AGENDA

A **Meeting of Traffic Committee** will be held on Cammeraygal Land at the Council Chambers, 200 Miller Street, North Sydney at 10:00 AM on Friday 15 March 2024.

5.1. Young Street and Grosvenor Street, Neutral Bay - Cycling and Walking Upgrades

Image 3. Updated design in response to community submissions

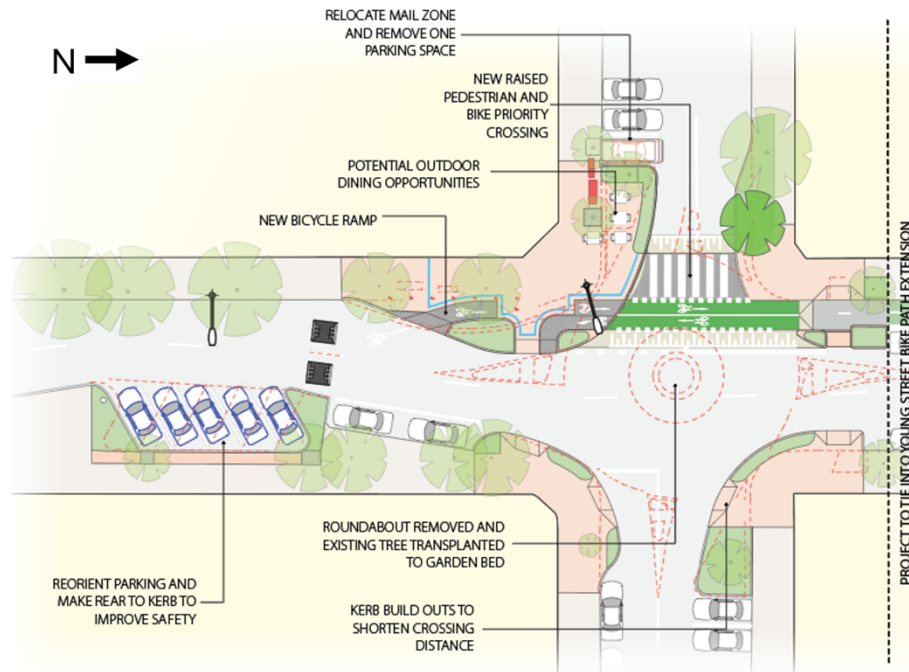
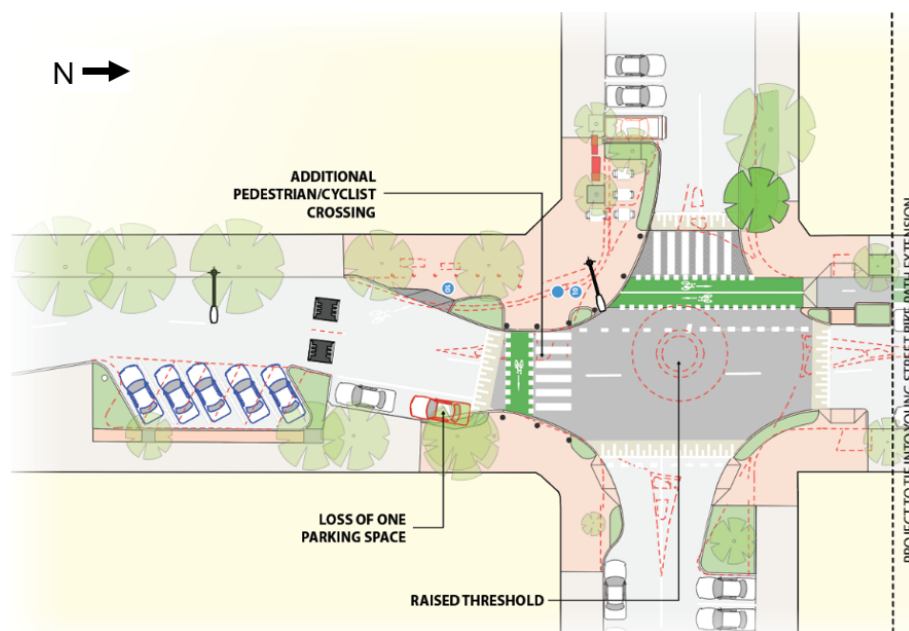
In response to community submissions, the following changes are proposed to the design:

- An additional pedestrian/cyclist crossing on the south side of the intersection.
- The entire intersection will be raised, slowing traffic on all approaches to the intersection.
- A loss of one additional parking space to accommodate the additional crossing.

(ID038) Albany Street, Crows Nest– Proposed Dedicated Car Share Bay

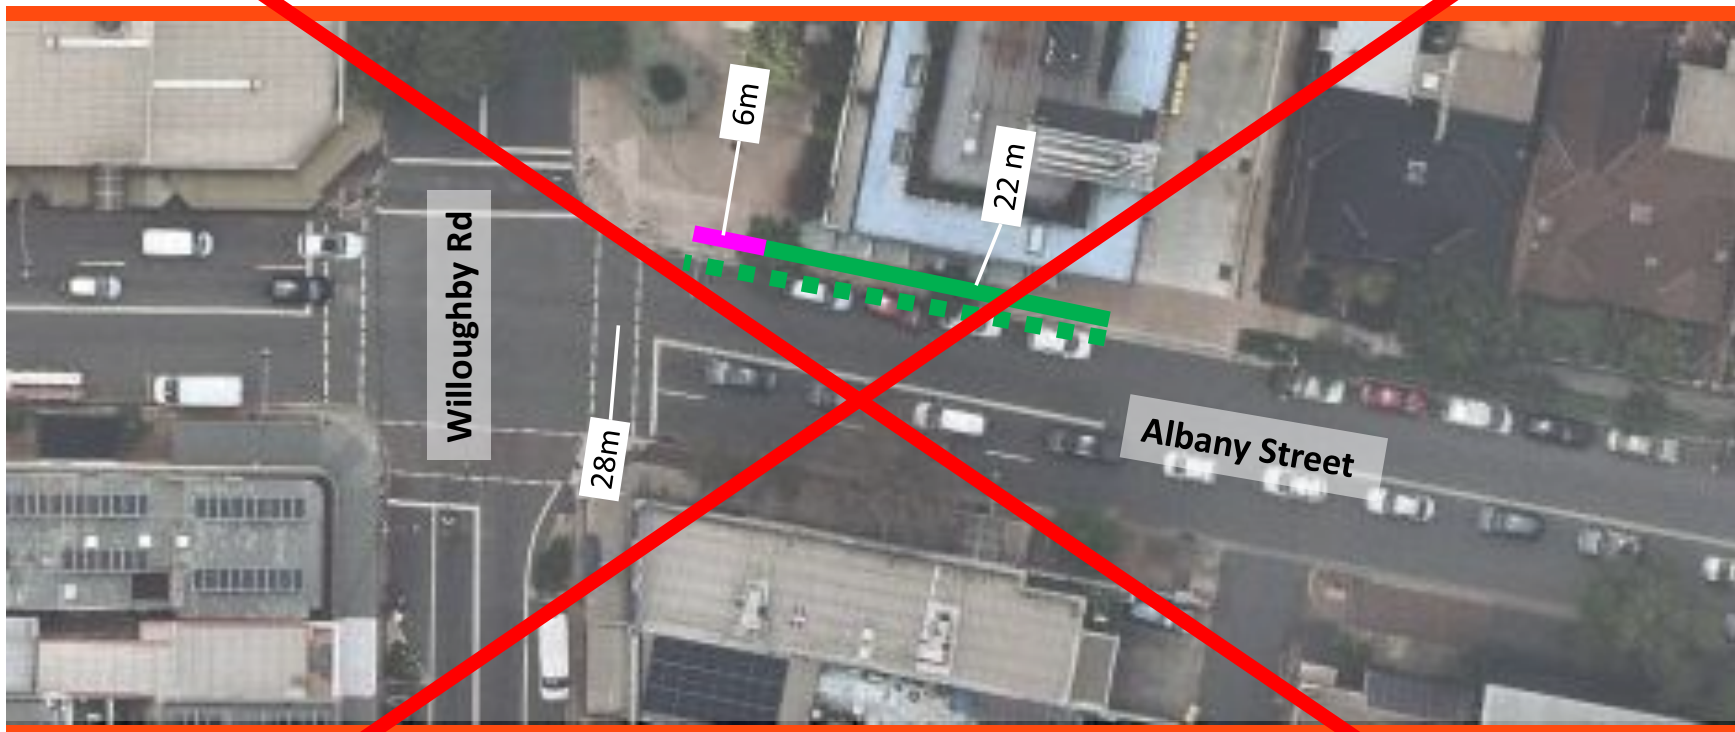
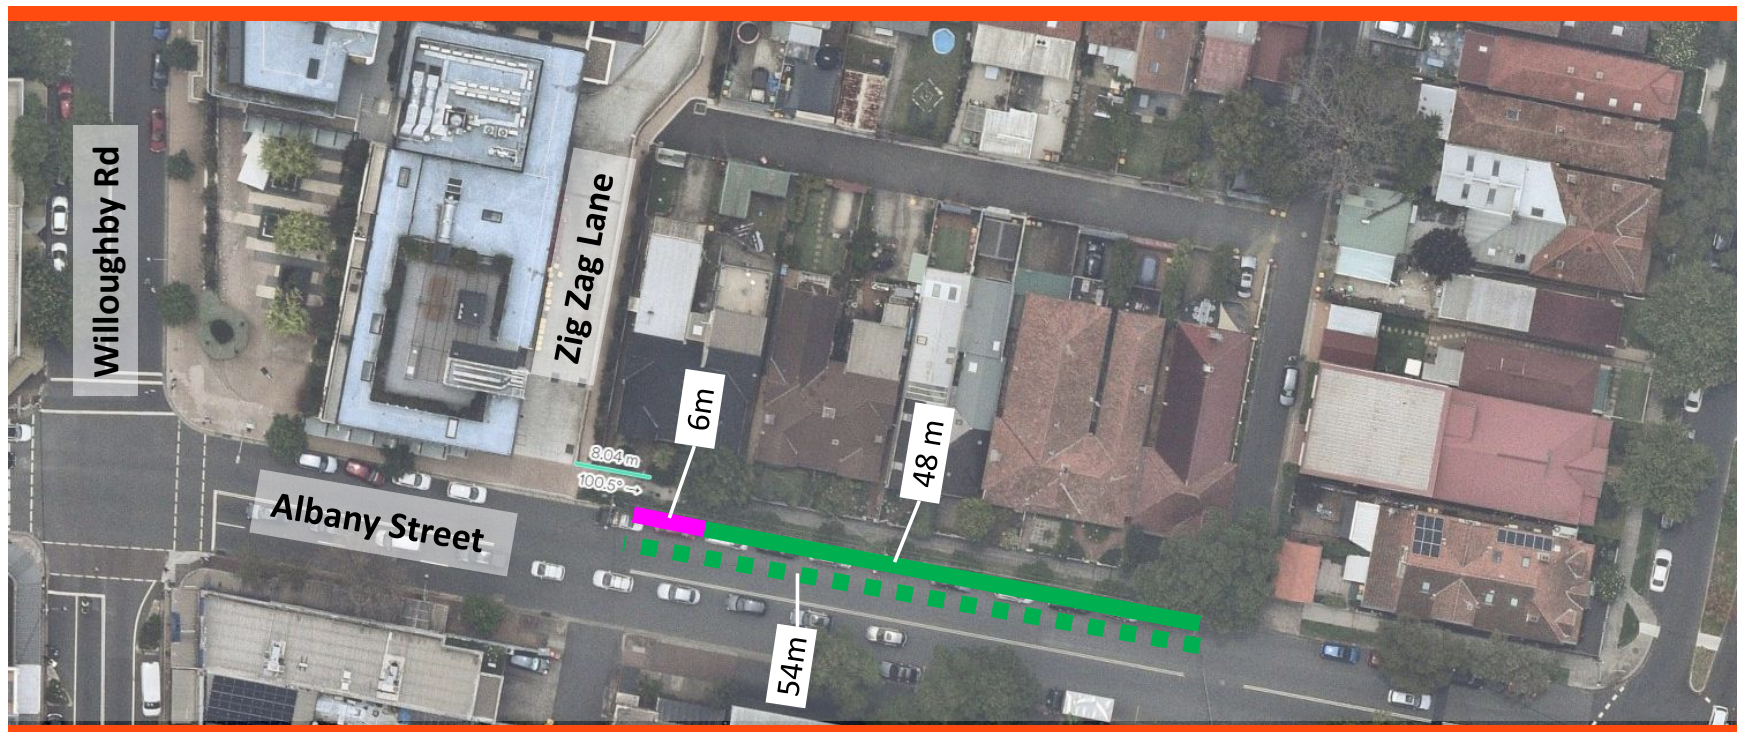
- moving the location further east down Albany Street to accommodate childcare drop off.
- Using car share payments to subsidise parking permits

Proposal – relocated in response to submissions
